REQUEST FOR PROPOSAL (RFP)
ADDENDUM NUMBER ONE (1)
DATE: July 2, 2025

PROJECT: Flight Information Display System
Birmingham-Shuttlesworth International Airport
Birmingham, Alabama

Reference to #17 – TBIDS Enclosure

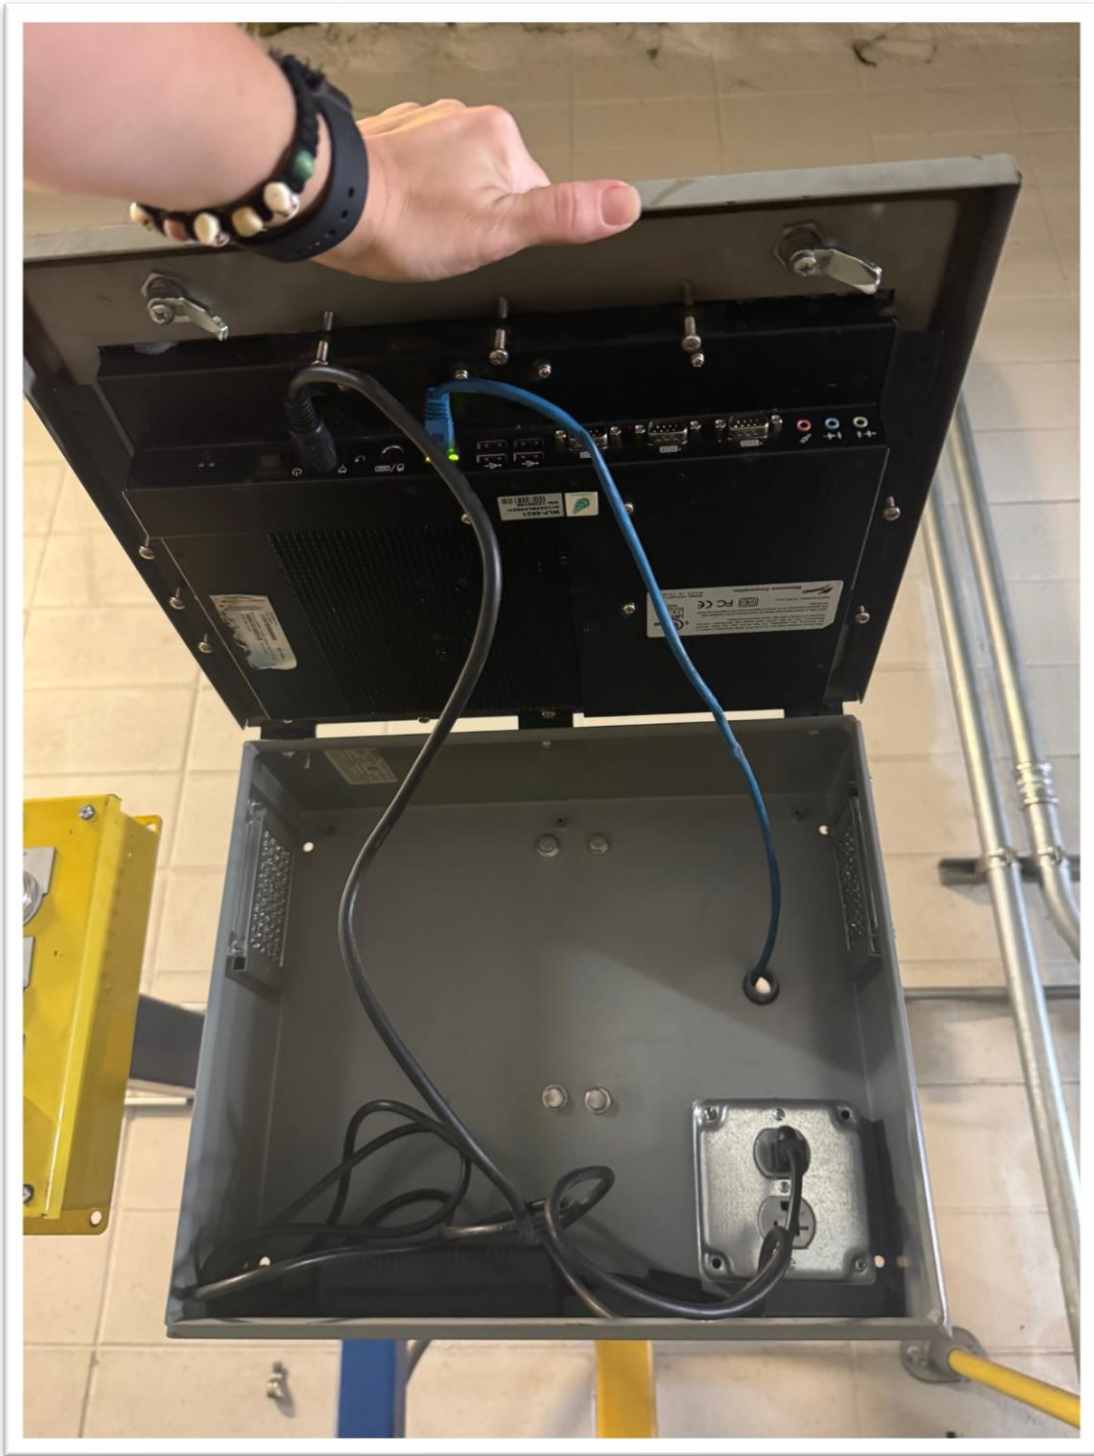
17. Question: Can BAA provide photos of the current TBIDS units, including: The device/player itself, Mounting hardware and placement, General surrounding environment (e.g., enclosure, exposure to elements).

Answer: The TBIDS are exposed to extreme temperatures but are protected from wind, rain, and snow. Please see photo below for reference.

Reference to # 20 – Standing FIDS Enclosure – Front view

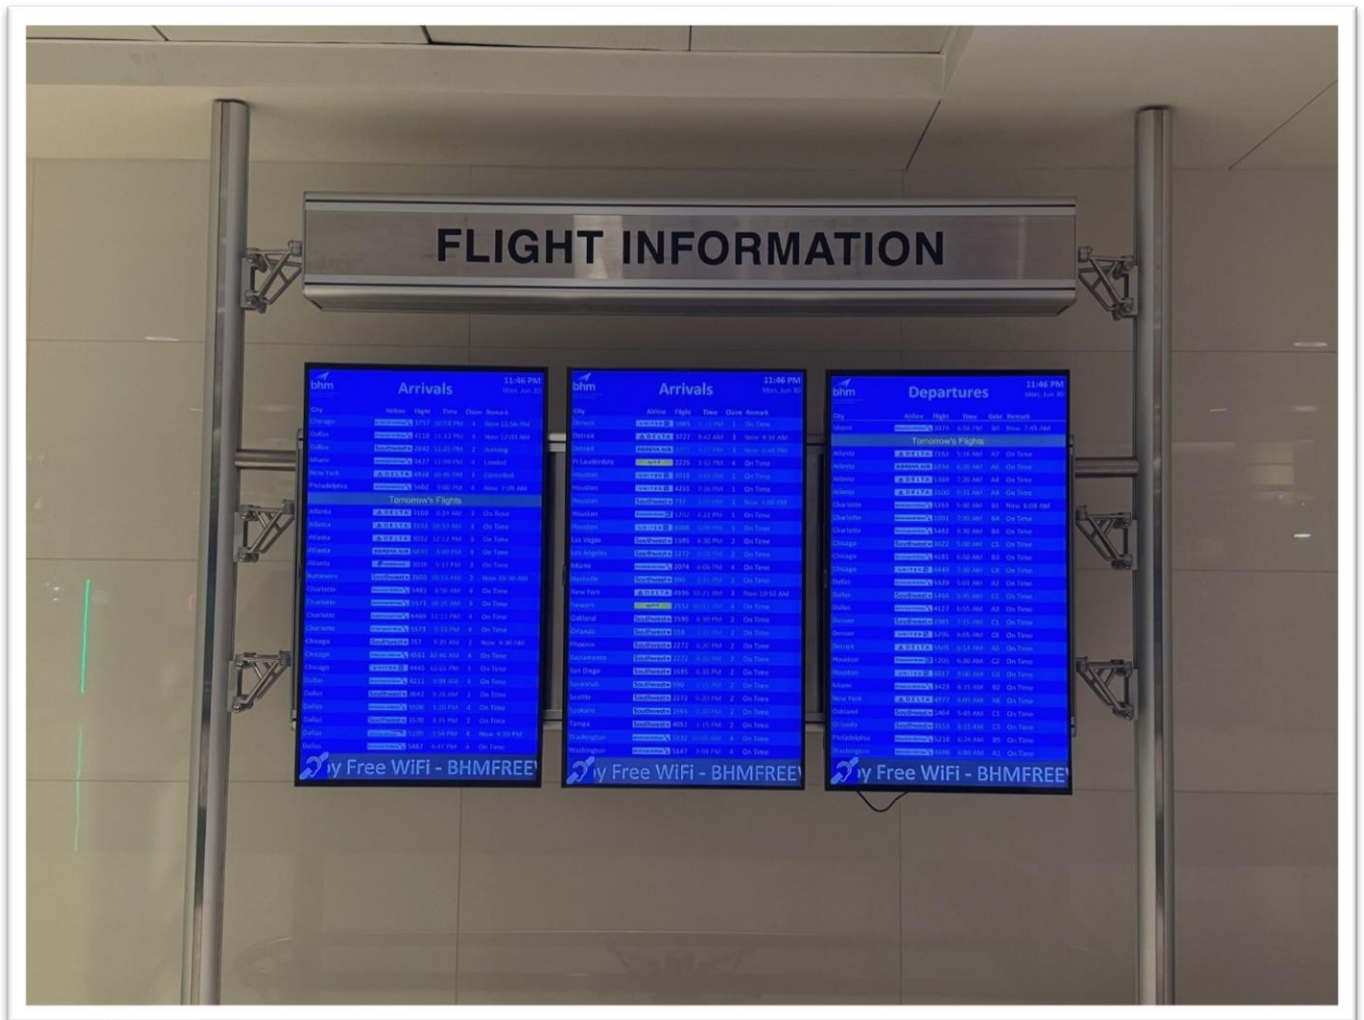
20. Question: Are any general installation photos available to help vendors understand the current configuration of players, screens, mounts, and cabling?

Answer: Attached are photos of our main Hanging FIDS, Standing FIDS, and our GIDS. There are no photos of the inside of the Hanging FIDS but it is a large open area back behind the monitors and power and ethernet are located there as well. The GIDS power and ethernet are in the panel directly below the monitor with plenty of room. The GIDS panel slide up and off for access to player and power.
